Environmental Impact Report

LDR No.92-0466
SCH No. 92101036

SUBJECT: Scripps Gateway, GENERAL PLAN/COMMUNITY PLAN AMENDMENT, TENTATIVE MAP, REZONE, PLANNED RESIDENTIAL DEVELOPMENT PERMIT, PLANNED COMMERCIAL DEVELOPMENT PERMIT, PLANNED INDUSTRIAL DEVELOPMENT PERMIT, A HILLSIDE REVIEW PERMIT, A STREET VACATION AND EASEMENT ABANDONMENTS to amend open space areas identified on-site within the Miramar Ranch North Community Plan, subdivide the 242.1 acre property into 354 lots and a rezone including: 309 single-family lots (rezoned from, R1-8,000 and R1-10,000 to R1-5,000 and R1-6,000); one 8.3 8.2 acre multi-family lot for 135 multi-family residences (zoned R-1500); seven lots totaling 14.5 14.3 acres for commercial development (zoned CA) including a 1.5 acre park and ride lot and a 4.5 acre parcel on the southern side of Scripps Poway Parkway currently zoned M-IP; six lots totaling 30.1 acres for industrial development (zoned M-IP) and 11 lots totaling 19.6 20.2 acres for brush management. Four lots totaling 86.4 85.9 acres are designated for open space while fifteen 16 additional lots are provided for signage and open space and NPDES basins. An overlook site is also provided. The pr

FIGURE 3-7

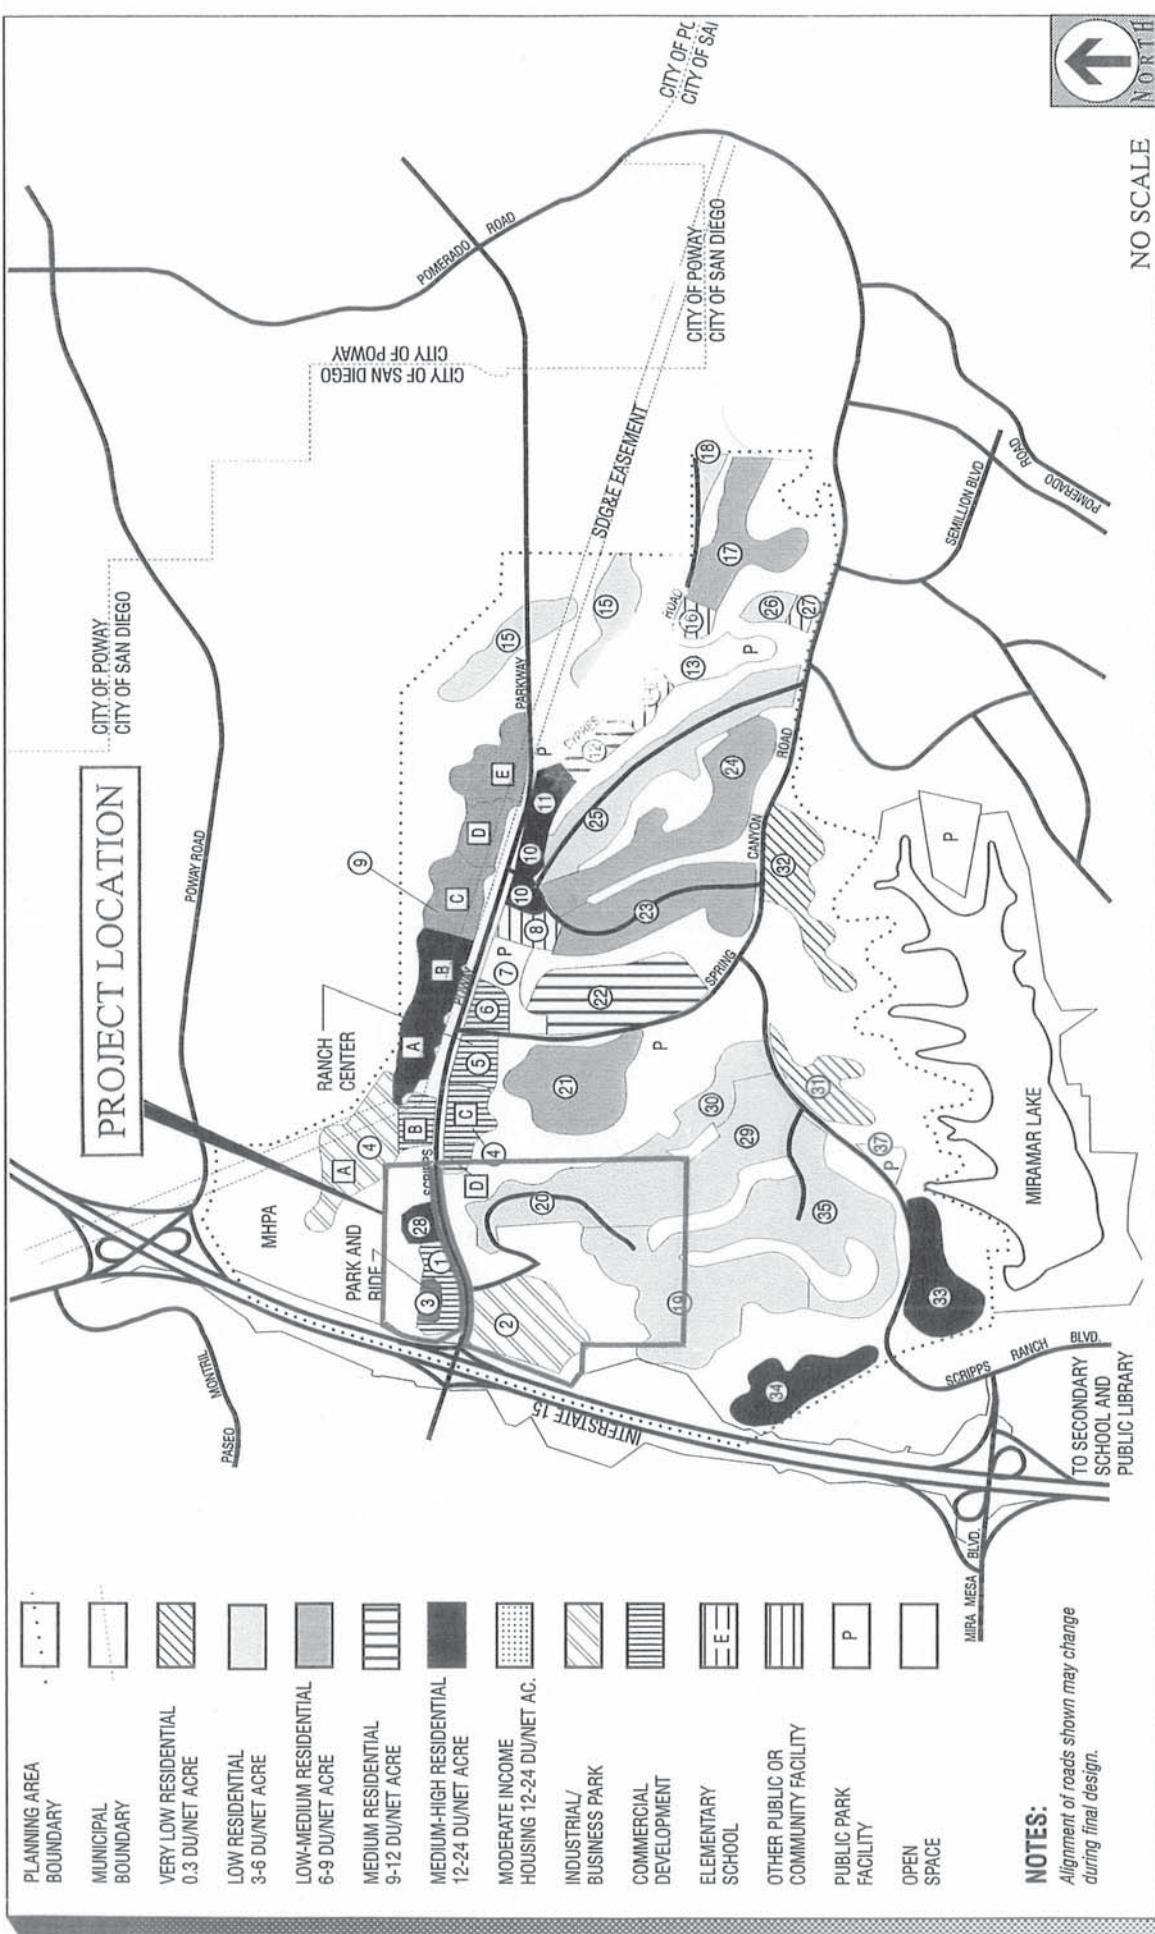
three residential parcels (19, 20, and 28) that comprise the Scripps Gateway PRD and multi-family portion of the PCD; (2) physical configuration of the commercial and park-and-ride parcels; (3) adds a two-lane collector road where a local road was previously anticipated; and (4) changes the designation of Parcel 4D from industrial to commercial. These changes are shown in Figure 3-7 of the EIR (compare to Figure 3-1 of the EIR).
